4.18 STEAM GENERATOR TUBING SURVEILLANCE

ATTACHMENT 2

SIGNIFICANT HAZARDS CONSIDERATION (SHC) DETERMINATION

This change request includes the following changes to ANO-1 Technical Specifications 4.18 pertaining to Steam Generator Tubing Surveillance.

FIGURE 4.18.1

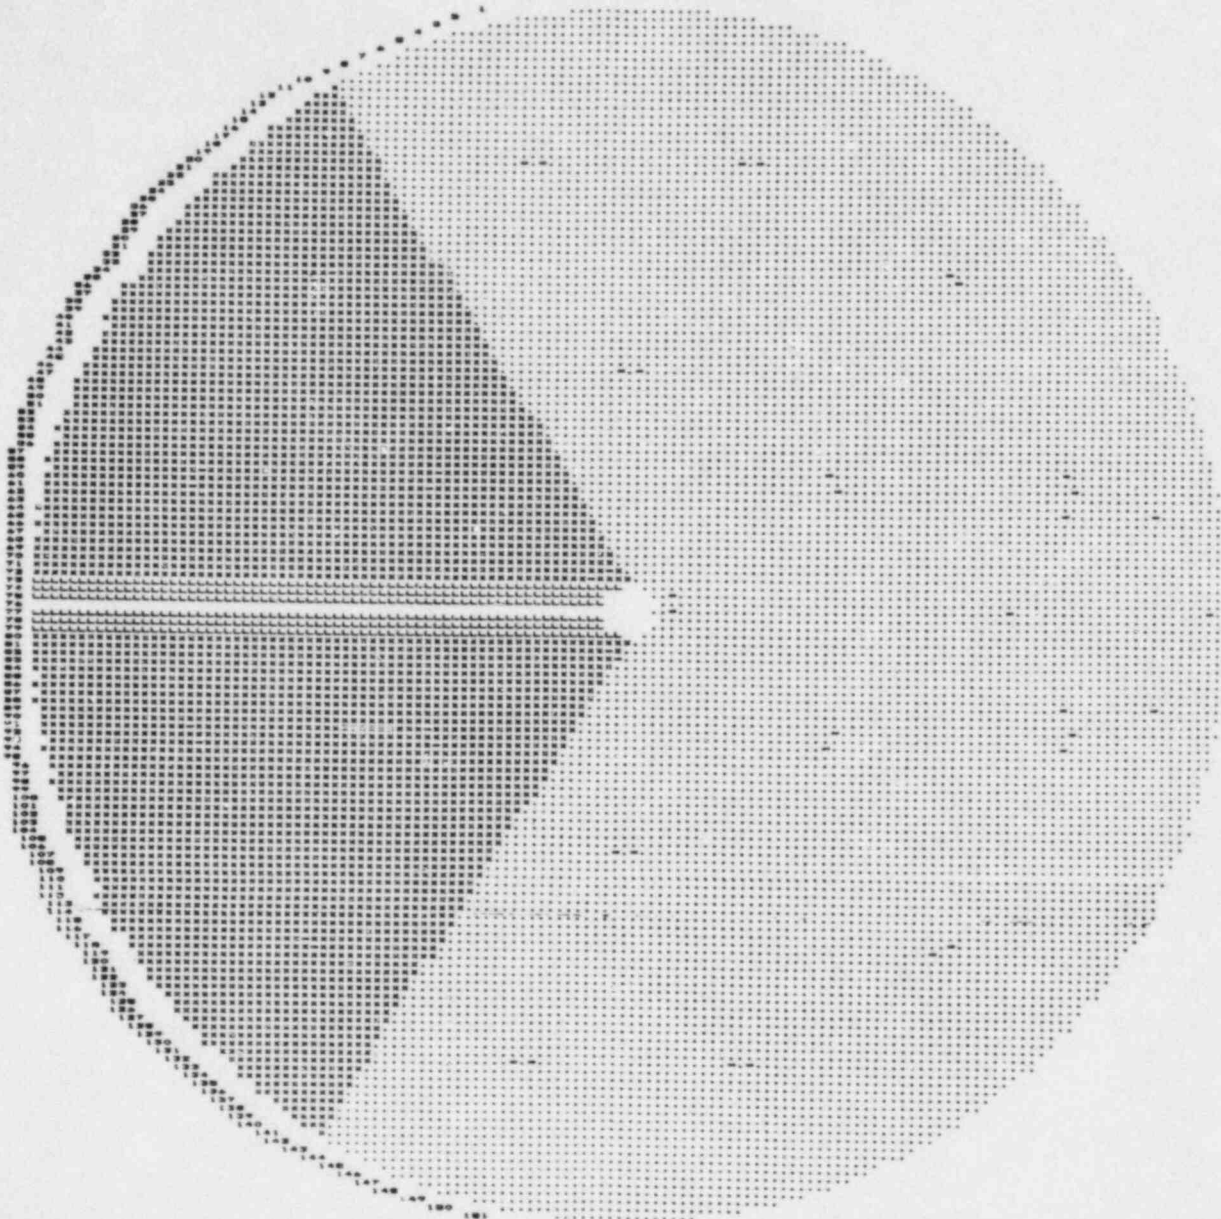
- d. Technical Specification 4.8.3.a.3(3): A new special group A-3 is added. The new group is defined by a new Figure 4.18.1.

The new special group consists of 4,831 tubes adjacent to group A-1, the lane region. The new group is a large wedge (~1/3 of the tube bundle) originating at the center of the bundle fanning out on either side of the lane region. This new special group is selected due to tube degradation noted in recent steam generator tubing inservice inspections and recent leaker outage tube inspections. Sample analyses performed on tubes pulled during recent inspections have shown that intergranular attack (IGA) is the root cause of tube degradation leading to the plugging of ~280 tubes in the OTSGs. This attack has been concentrated in an around the lane region, group A-1, and at the periphery of the tube bundle near the lane. The proposed group A-2 more than adequately bounds the region of degraded tubing found to date.

Since the 1R5 outage the generators have been subjected to two additional inspections, a July 1983 leaker outage in which the A-OTSG was subjected to a limited inspection and a March 1984 mid-cycle inspection during which the tubes making up the wedge shown in proposed Technical Specification Figure 4.18.1 were examined from the 15th TSP up in both generators. As a result of these two inspections 75 tubes were plugged in the A-OTSG and 36 were plugged in the B-OTSG. Therefore, currently there are 196 tubes plugged in the A-OTSG and 88 plugged in the B-OTSG.

Prior to the 11/82 (1R5) outage 26 tubes had been plugged due to service related defects/indications. All 26 tubes were in the A-OTSG (no defects had been recorded in the B-OTSG prior to the 11/82 outage). Twenty two of these defects were located at the upper tubesheet (UTS) secondary face or within the upper tubesheet (UTSM). All twenty two of these defects would have fallen into this new A-3 special group.

The 100% eddy current examination performed during the 11/82 (1R5) refueling outage identified 83 tubes with pluggable defects in the A-OTSG and 45 tubes with pluggable defects in the B-OTSG. The majority of these defects were located in the UTSM (69 tubes with UTSM defects in A-OTSG and 34 tubes with UTSM defects in B-OTSG).

The UTSM defects in both the A&B-OTSG's were located predominantly in a quadrant around the open lane. Defects below the UTS were scattered randomly over the entire tube bundle. Of these defective tubes, 66 in the A-OTSG and 29 in the B-OTSG would have been detected while conducting a special inspection of the new A-3 group from the 15th TSP up. The defects in the remainder of the tubes located within the bounds of the special group (4 in the A-OTSG and 4 in the B-OTSG) were randomly dispersed below the 15th TSP.

The results of the March 1984 mid-cycle outage also supports the proposed configuration of the new A-3 group. During the mid-cycle inspection, an examination identical to that proposed by the new special A-3 group was conducted. The defective and degraded indications identified during this inspection (excluding those tubes with previously reportable indication) all fell well within the bounds of the large wedge defined by Figure 4.18.1. The heaviest concentration of degraded tubes were found within 10 rows of the lane and around the periphery either side of the lane.

The majority of the IGA found to date has been located at and above the secondary face of the upper tube sheet. The inspection of the proposed new A-3 group from the 15th TSP up should provide adequate monitoring of the IGA problem.
